HOUSE 4 — HOUSE 5

Revised Design for Conversion of
Existing Listed Barns and Proposed
Four Barn Style Dwellings with
Covered Parking and Associated
Works at Site West of Lordship
Farmhouse, Pirton Road, Holwell
Hertfordshire

REVISION 'A' MAY 2026
Amended Elevational Detailing
to all Six Dwellings

Unit 4

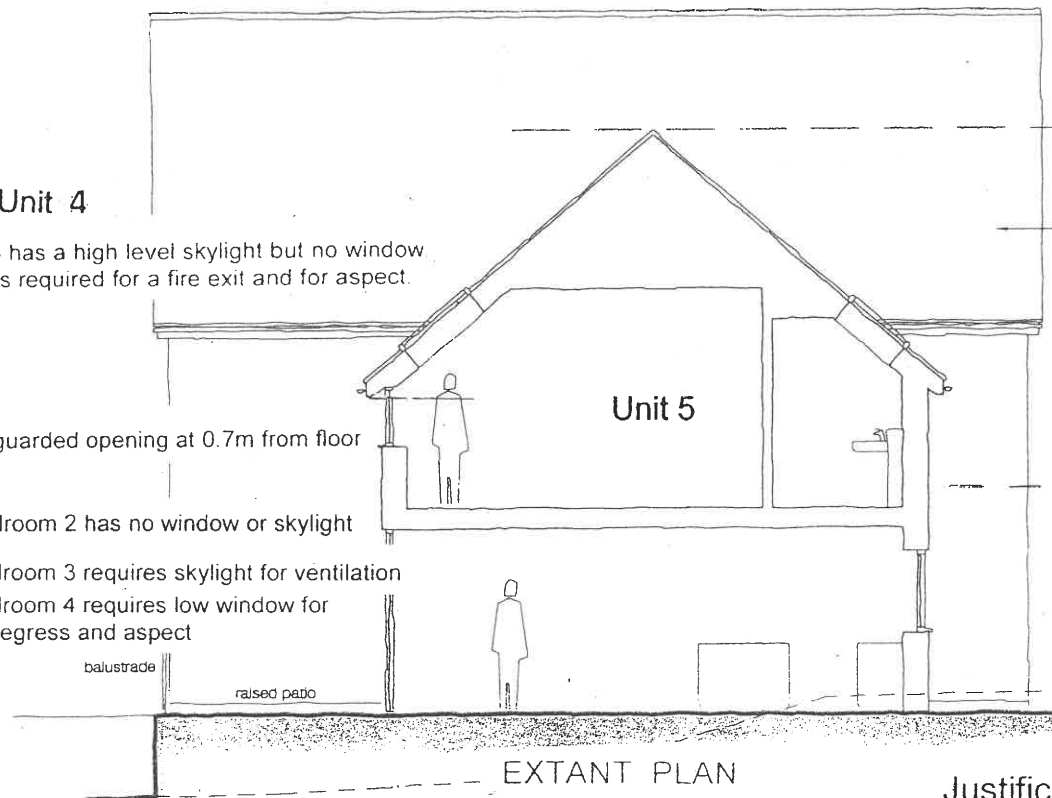
Bedroom 3 has a high level skylight but no window.
A window is required for a fire exit and for aspect.

Unguarded opening at 0.7m from floor

Bedroom 2 has no window or skylight

Bedroom 3 requires skylight for ventilation

Bedroom 4 requires low window for fire egress and aspect

Justification for change of roof pitch
